RE: Electric Owl Holdings, LLC: Petition to Amend the Code of the Village
Site: One South Broadway, Hastings-on-Hudson, New York

On behalf of Electric Owl Holdings, LLC (the "Applicant"), we respectfully submit this letter in response to comments from the Board of Trustees, including Trustee Morgen Fleisig and Trustee Douglass Alligood, regarding the project. This letter further supplements the Application and follows the most recent letters submitted on November 22, November 30, and December 4, 2023 by Cuddy & Feder LLP on behalf of Electric Owl Holdings, LLC (the "Supplemental Letters").

DRAWING NO: **L 3.0**
SITE SECTIONS A

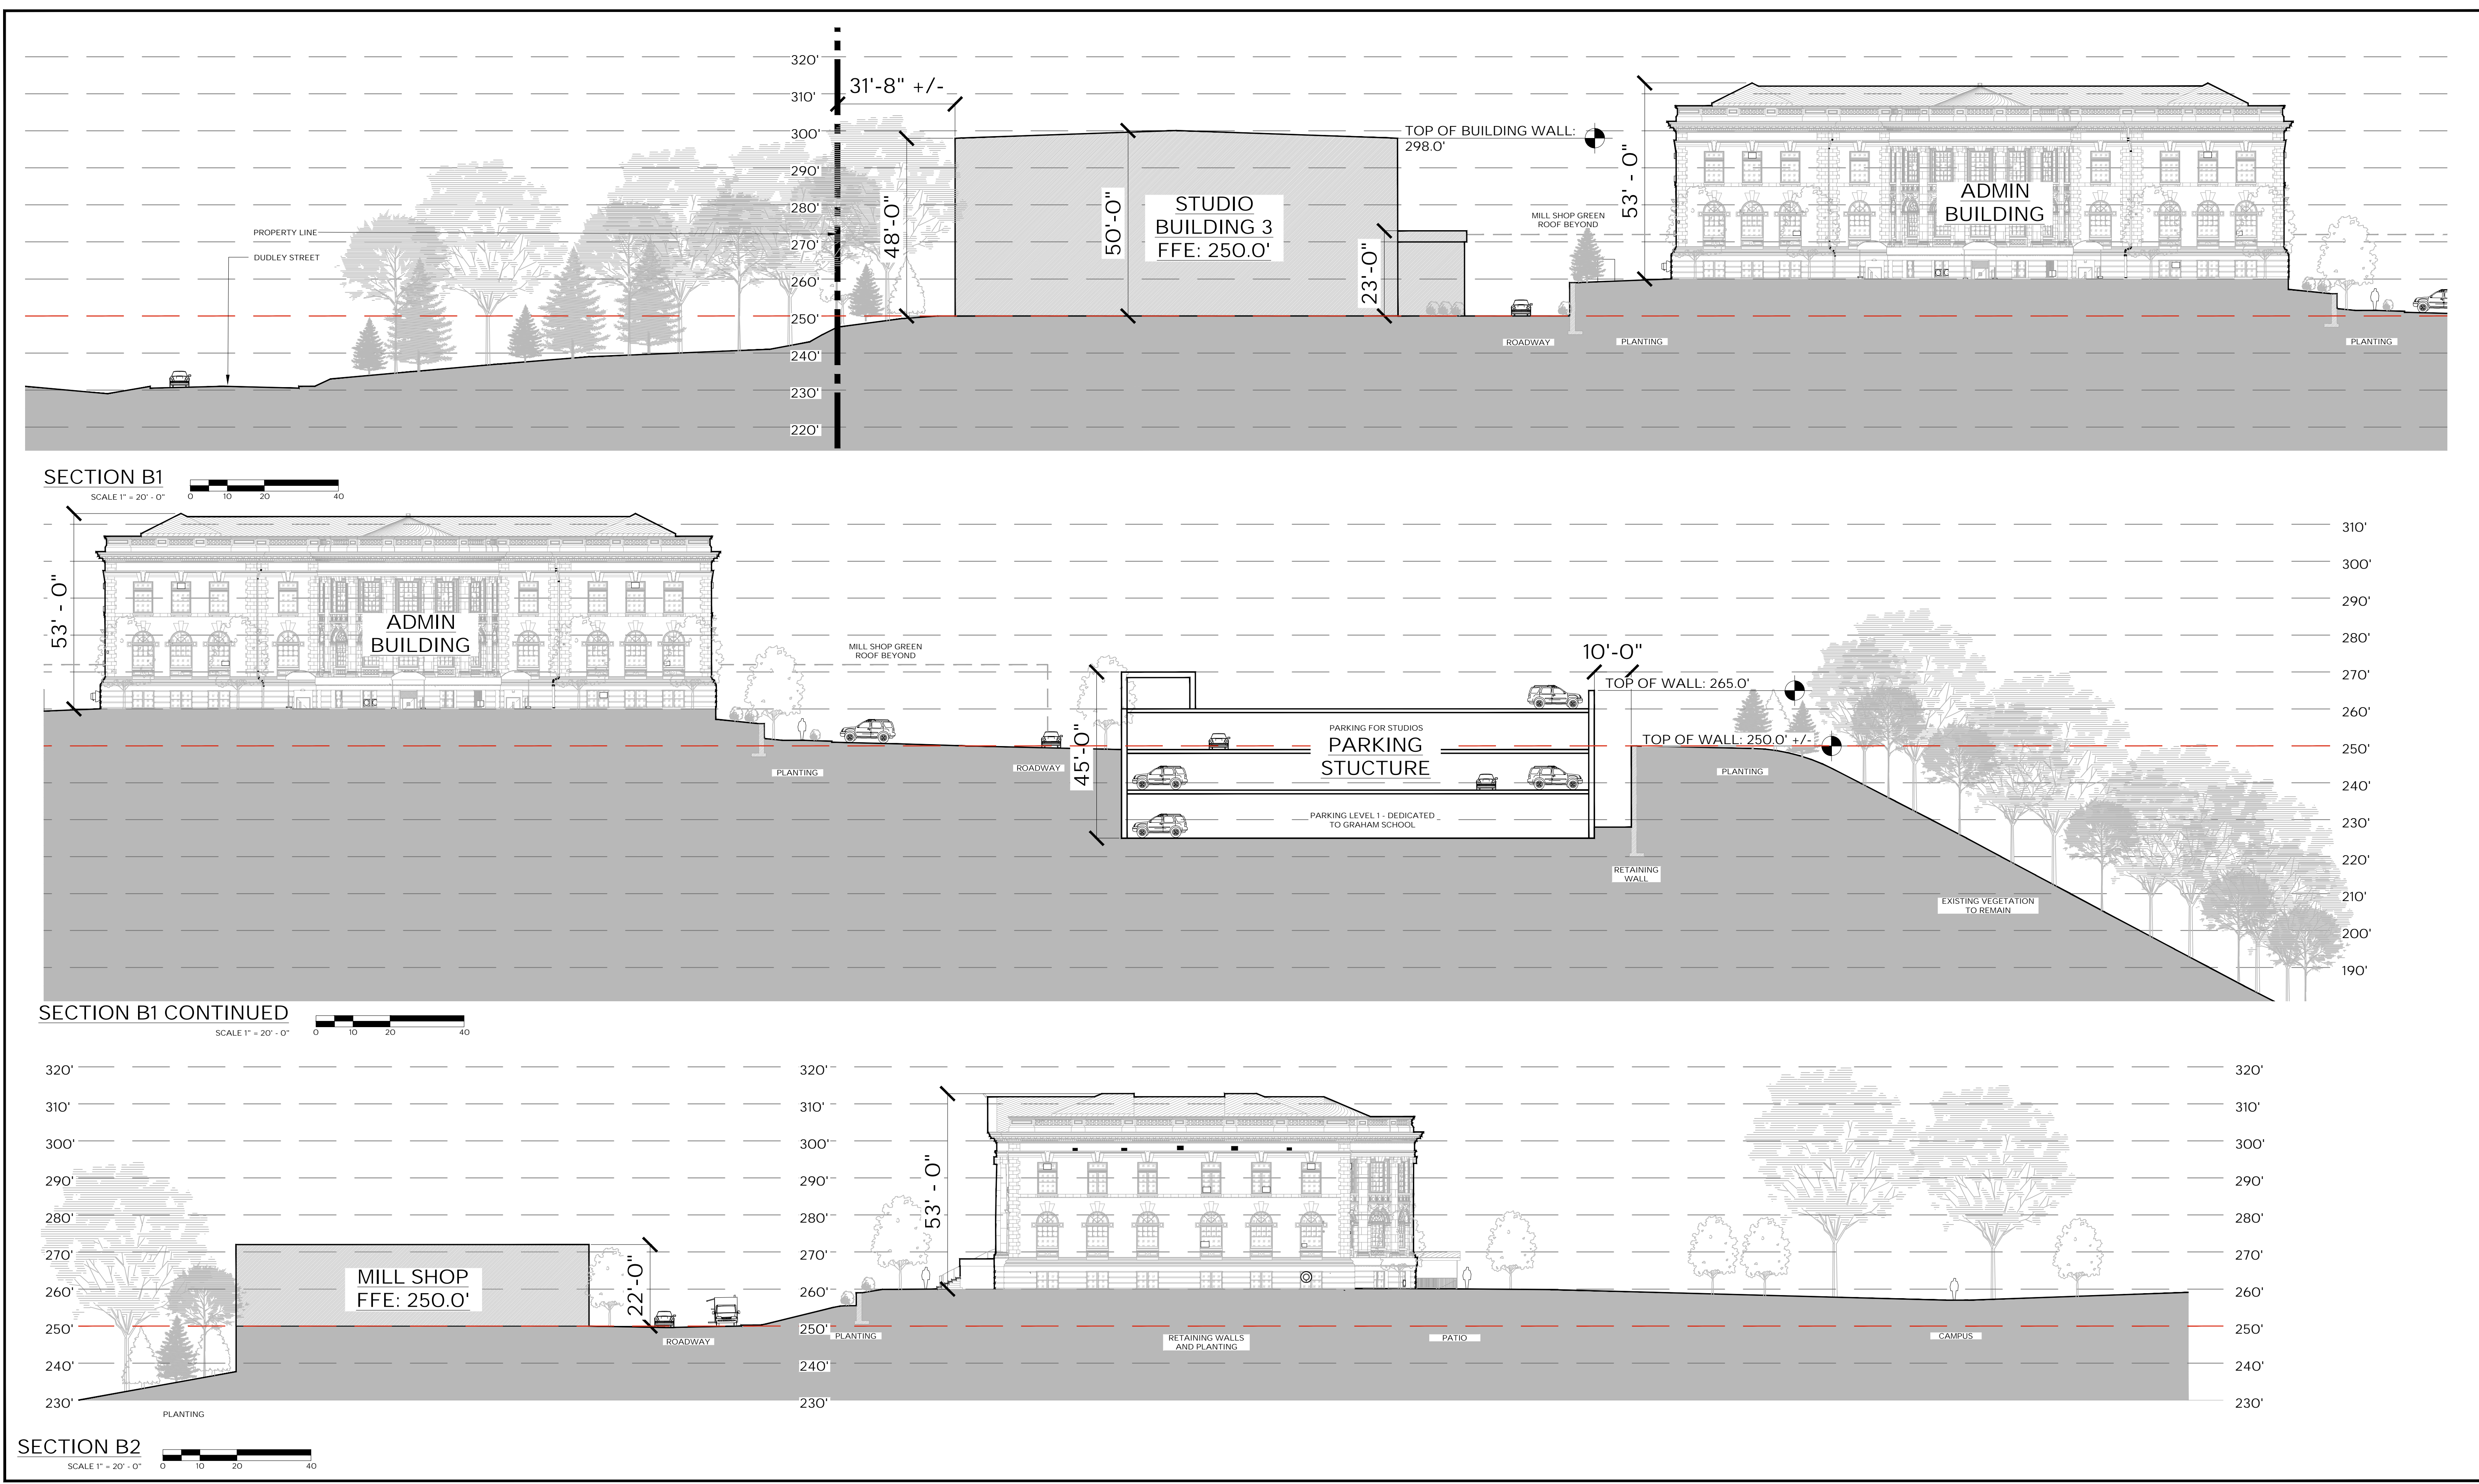
5. Can the Site Sections be updated to show the adjacent grading more clearly?

These plans have a red-line demarcation indicating the 250-foot topographic contour and note that Dudley Street is at elevation 230-feet.
